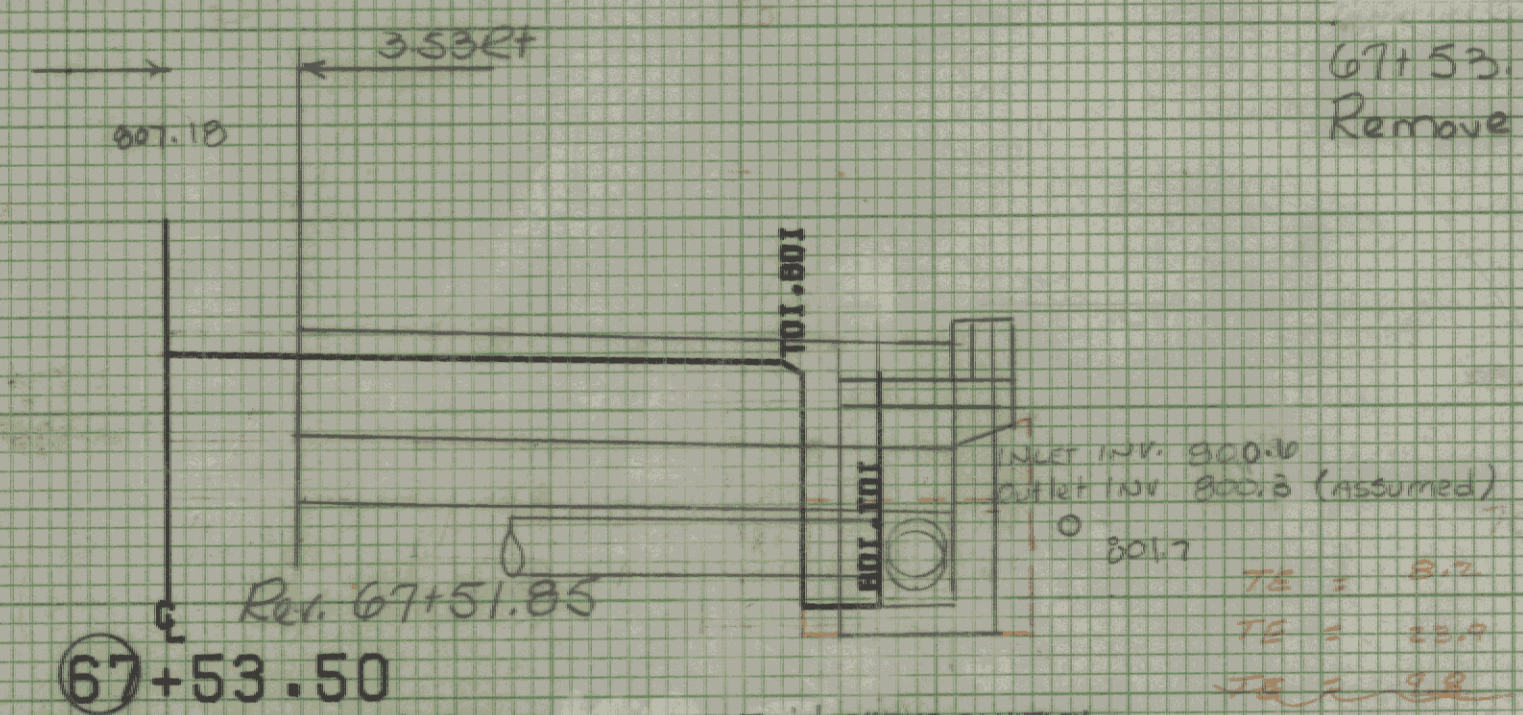
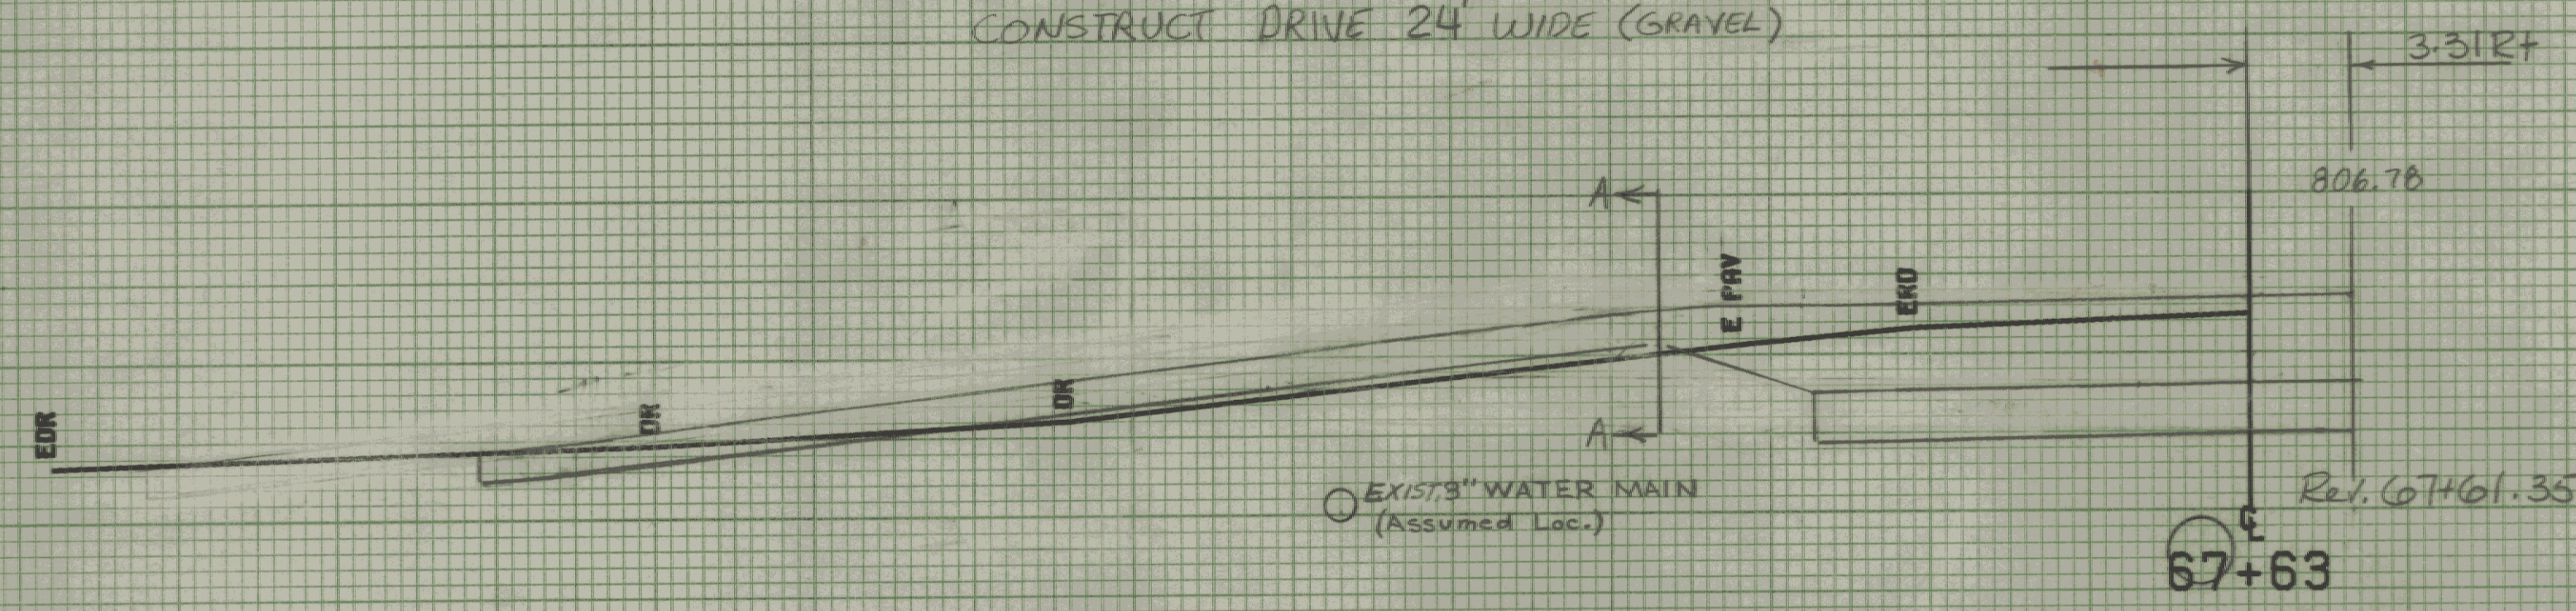
REV. 67+70 LT.
CONSTRUCT DRIVE 24' WIDE (GRAVEL)

67+60 RT
End Vertical Granite Curb

REV. 67+57 LT
End Vertical Granite Curb

REV. 67+58.74
End Project MEGC-M6400(7)
Begin Approach

REV. 67+52 RT ~ 67+94 RT
Relay 40' Existing 18" RCP
Connect to New RCDI @ REV. 69+52 RT

67+53.50 RT
Remove Existing 4' x 4' RCDI

Remove Existing 18" x 28" RCP
REV. 67+50 LT ~ 67+52 RT
New 18" x 30" PCCSP.064 or
CAAP.060

REV. 67+52 RT
End 18" x 128" PCCSP.064
or CAAP.060

REV. 67+51.5 LT
Remove Existing RCDI
